CANDLESTICK POINT–HUNTERS POINT SHIPYARD PHASE II DEVELOPMENT PLAN PROJECT

Volume V: Final EIR Comments & Responses (Letter 50 through Letter 86)

Comments & Responses

FIGURE II-8

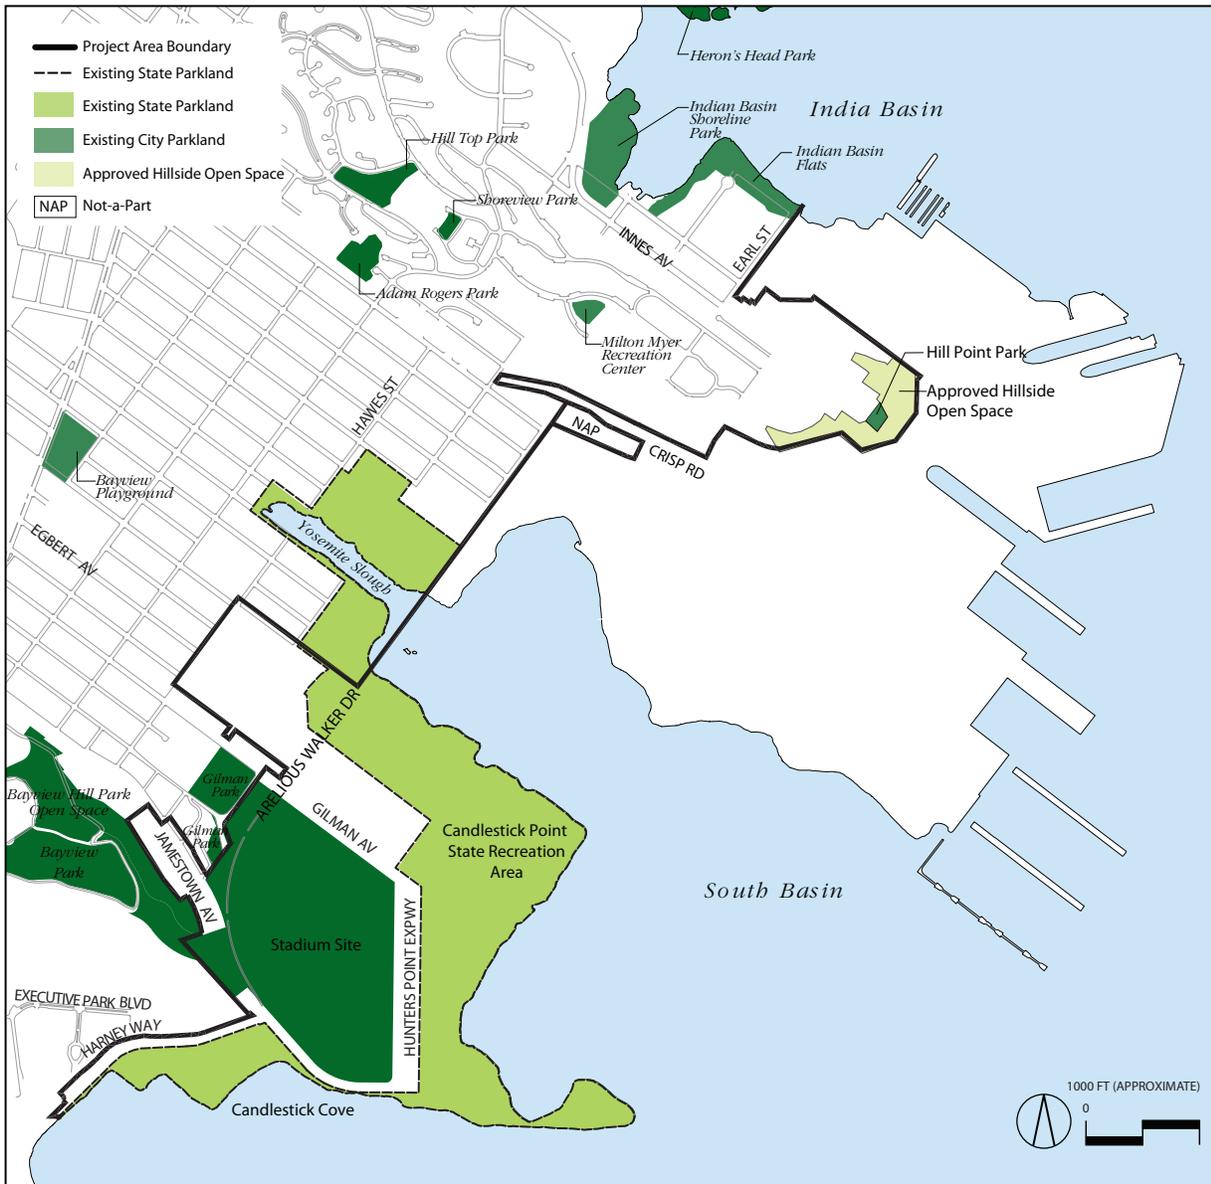
Figure II-8 - the caption includes “approved” parks. But nothing on the key shows “approved” - just existing. Please clarify or correct.

open space is approved and not yet completed. In response to this comment, Figure II-8 has been revised to indicate “Approved Hillside Open Space.” In addition, the boundaries of Bayview Park near Candlestick Stadium have been revised on Figures II-8 and II-10.

FIGURE II-10

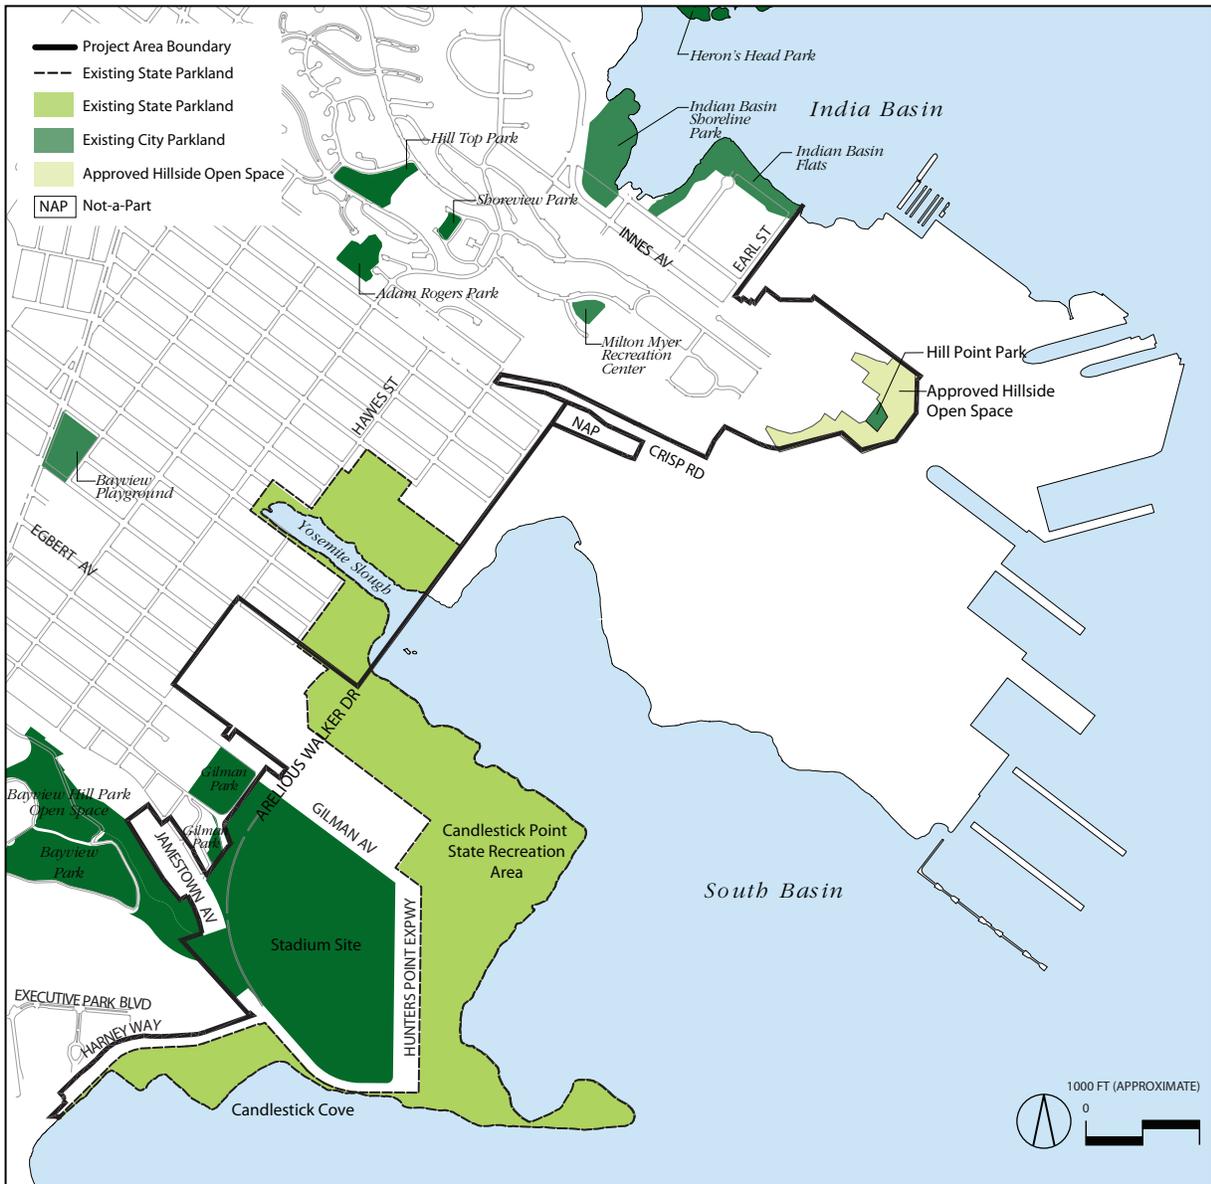
Figure II-10 - The Yosemite Slough boundary/line is even more ambiguous on this graphic. What is that weird red line? Does it show state parkland to be removed? Further, just south of Harney there is a skinny green area with an apparent red-cross-hatching. Is this also proposed to be removed? This graphic is really hard to read.

Figure II-10 has been revised and presented in Response to Comment 50-23 to correct the legend and clarify the park boundaries around the stadium site.
